XT3 ENDURO SERIES

Date: March 08, 2017

Subject: Damaged Throttle and Choke Cables From Heat

MANDATORY REPAIR

FIGURE 1

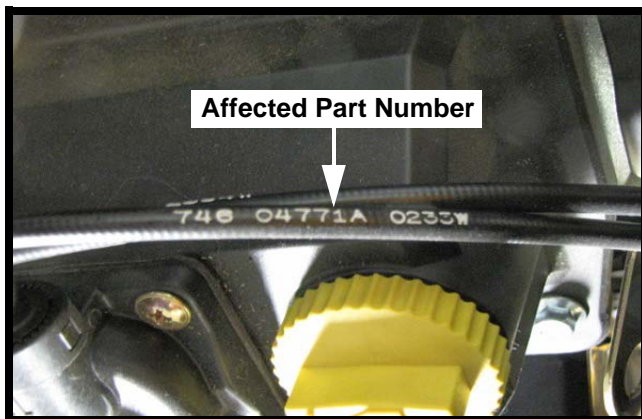
1. Check and Identify both throttle and choke cables on all affected Models listed above in the Serial Number Range Affected for the affected cable part number in white on the black casing of the cables. See Figure 1.

2. If the part number on the throttle cable is **746-04771A** and the part number on the choke cable is **746-04759A**. The cables need to be replaced with the revised part numbers, proceed to Step 5.

FIGURE 2

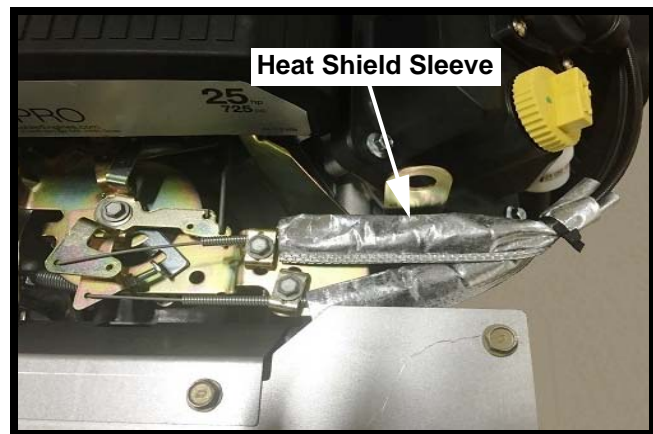
3. If the part number on the throttle cable is **746-04771A** and the part number on the choke cable is **746-04759A** and the cables are covered with a heat shield sleeve, see Figure 2. No further action is required.

NOTE: The heat shield sleeve is Not required with the "B" version cables.
